**Our Case Number:** ABP-317809-23

**Re:** Proposed Coolglass windfarm and related works  
In the townlands of Fossy Upper, Aghoney, Gorreelagh, Knocklead, Scotland, Brennanshill,  
Monamantry, Coolglass, Crissard and Kylenebehy, Co. Laois.

**Your Ref:** SID-LS-2023-030

<b>Proposed Strategic Infrastructure Development (SID): Coolglass Wind Farm SID Application</b>
---

*Plate 2—LVIA VP9 Photomontage with contextual notation*

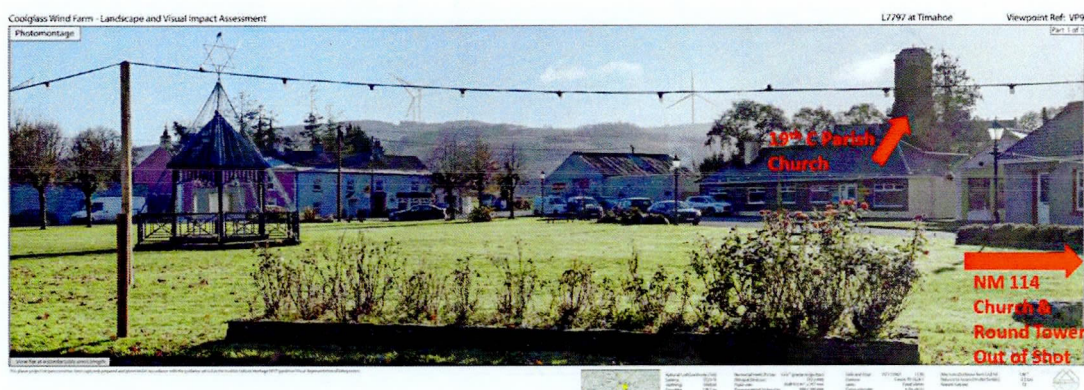
The Landscape and Visual Impact Assessment chapter of the EIAR presents only a single viewpoint (VP9) and photomontage as a basis from which to assess the visual impact of the proposed development to the National Monuments at Timahoe—Church and Round Tower (NM No 114; RMP LA018-031002-; LA018-031005-). None at all that are relevant for Fossy Church (NM No 114; RMP LA019-016----) or the motte and castle site at Ballinaclogh Lower (RMP LA024-015001-; LA024-015002-) that is subject to a Preservation Order (PO 4/1981) are included.

VP9 is located at the northeast side of the central green in the village of Timahoe, looking across that green towards the PDS. While the current 19<sup>th</sup>-century Catholic parish church in the village is within the viewshed for the photomontage, the site of the early medieval church and round tower is located further to the west, out of shot. No element of the National Monument appears in frame, however, the montage and supporting wireframe does indicate that at least four of the turbines will be prominent along the ridgeline of Fossy Mountain as viewed from the north and northwest.

The EIAR, as submitted, is potentially deficient as the baseline archaeological and cultural heritage environment has not been adequately characterised. The potential impact to the setting and amenity of the National Monuments at Timahoe and Fossy must also be more fully addressed. Therefore, the assessment of the likely impacts and effects of this development to the archaeological resource cannot be evaluated reliably. The Department recommends that permission should not be granted in this case before the inadequacies

*Plate 3—View south along R426, approximate locations of turbines based on EIAR*

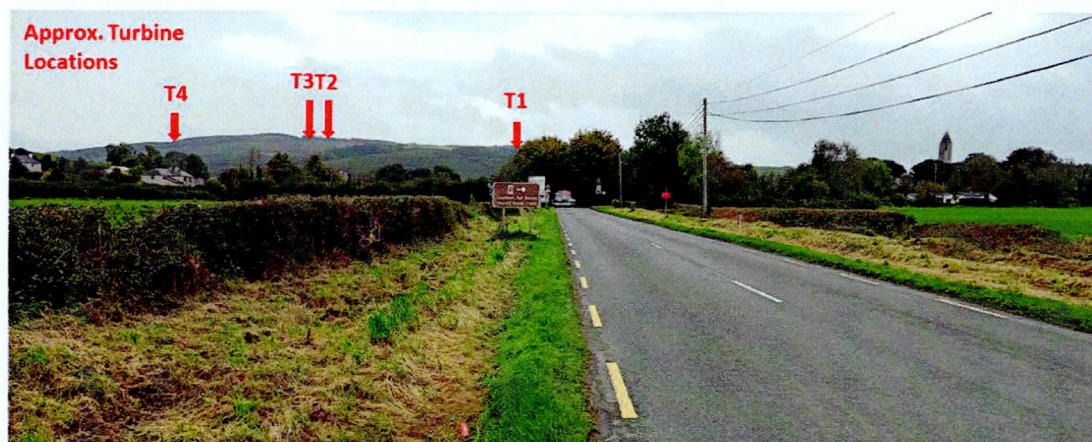
The inspection carried out by the National Monuments Service of the Department indicates that while the Department may concur with certain points made in relation to the vulnerability of these monuments to impacts on setting, the significance of the wider landscape setting of these monuments (and the vulnerability of that wider landscape setting) has been substantially understated in the EIAR. In this regard, the Department would draw particular

attention to the prominence and importance of the round tower at Timahoe in the landscape, as approached from the north along the R426 road.

*Plate 4—View south from local road L3840 towards Fossy Church, approximate locations of turbines based on EIAR*

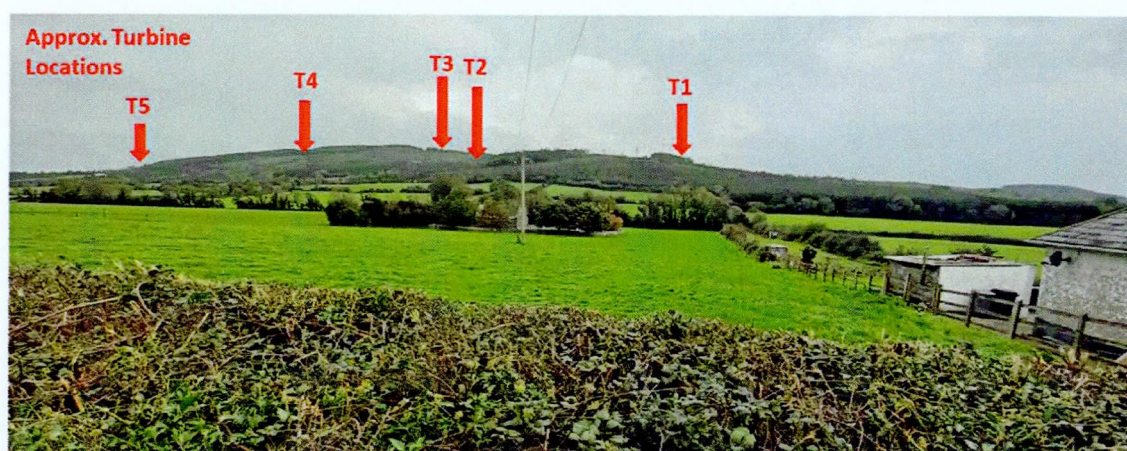
As noted above, there are extensive views of Fossy Church from local road L3840 to the north, against the backdrop of Fossy Mountain. The introduction of turbines visible along the ridgeline of Fossy Mountain will substantially impact this wider landscape setting of the site and detract from the public amenity.
